**Response to the Examining Authority's
Further Written Question QE.2.5**

**Neighbours and Users of
Queen Elizabeth Park**

Interested Party reference no: **20022545**

1. Response to ExA's FWQ QE.2.5

(Farnborough Hill School, listed building shown in red, 140 metre distance to the Order Limits indicated with orange arrow)

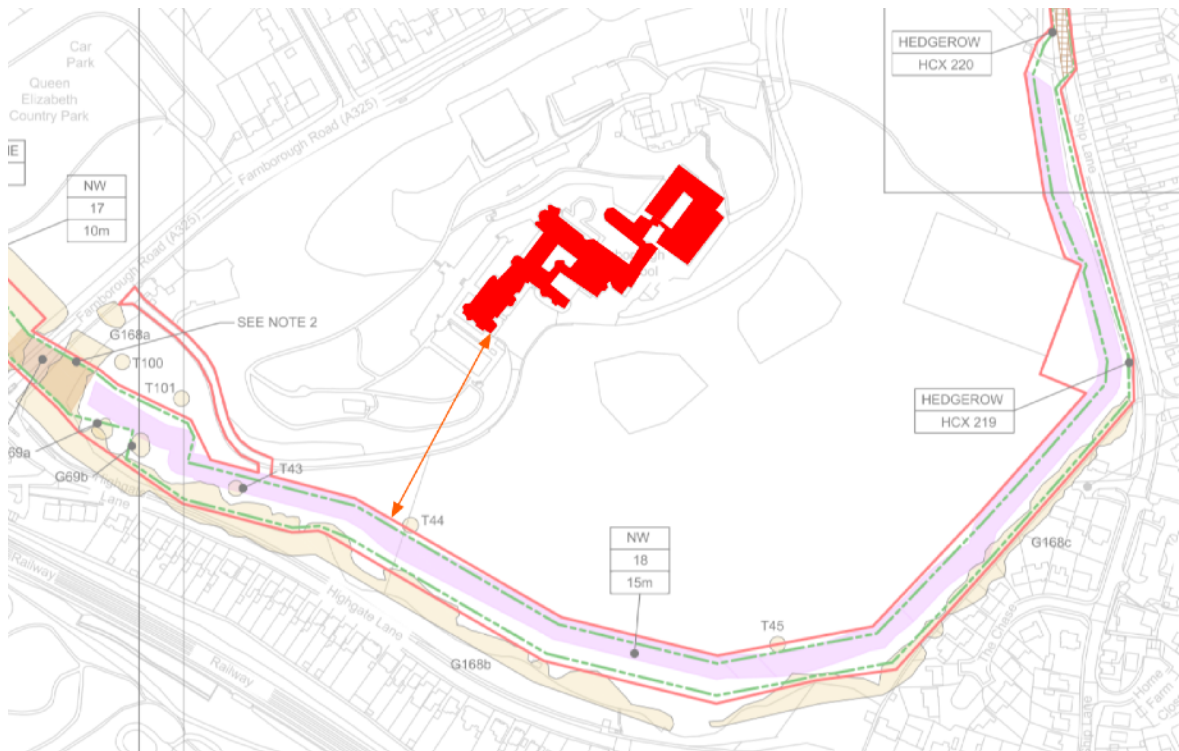
Esso's diagrams actually show two possible stringing areas which are mainly in, or very close to the Order Limits. Slight adjustment of the orientation of the reception pit could allow even better alignment of the stringing area substantially within the Order Limits.

We estimate that the smallest distance between the listed building and the Order Limits is about 140 metres. The works will be screened from view by trees and gradient changes. Threats to the structure are minimal and the risk of permanent damage to the setting is unlikely if the stringing area is carefully aligned.
